**Technical change to IE-SW-VL08MT-series
(8-Port Fast Ethernet managed Switches)**

- PCN-number: PCN-PN48-20180829-00-A
- date of publishing: 29th August 2018
- revision number: A

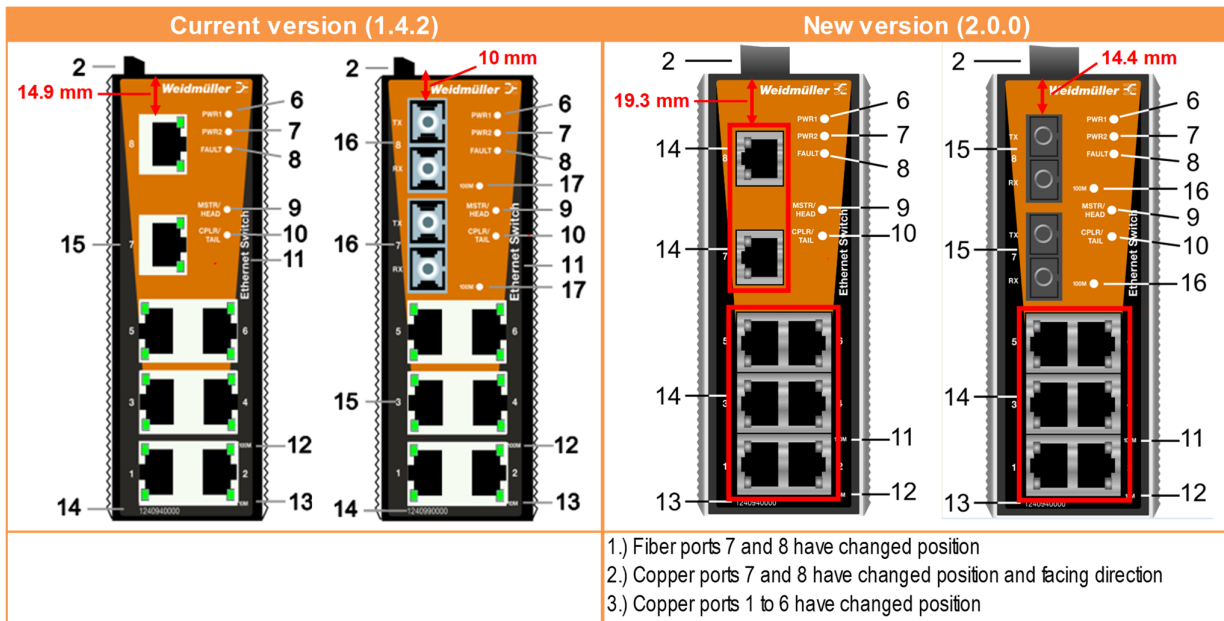
2.) Position of ports (fiber/copper) changed with new product version. Valid for products in table below. Refer to below figure for more details.
